Regular Meeting of May 16, 2006

SUBJECT: APPEAL OF DIRECTOR'S DECISION AND CONFIRM ALTERNATE CORNER

LOCATION: 1147 7TH STREET

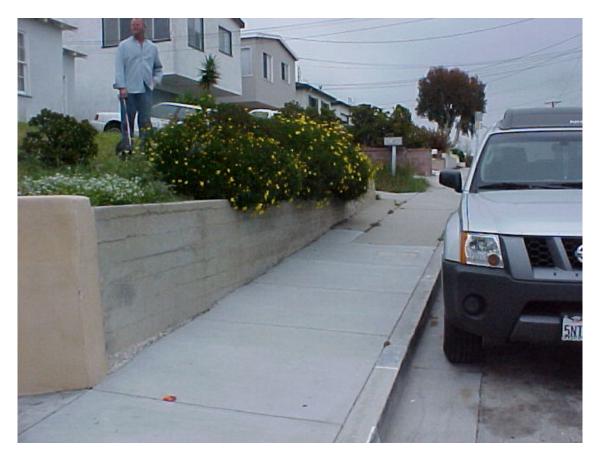
Though staff believes a convex condition exists it is not very pronounced, and the topographic profile shows that it only clearly exists along the east property line. Therefore, staff recommends recognition of a convex condition only along the easterly property line. The property like others on this section of the block located near the crest of 7th Street slope up in the front third of the lot before leveling off in the rear portion of the lot. This condition appears to be a convex slope condition along the easterly properly line (see survey and topographic profile).

In summary, staff believes that at the southwest corner the top of the retaining wall best represents unaltered grade and that at the northwest corner point the elevation should be based on one-half the difference between adjacent grades. The convex condition only applies along the east property line and the datum should be taken at the apex of the convex contour at elevation at 106.0.
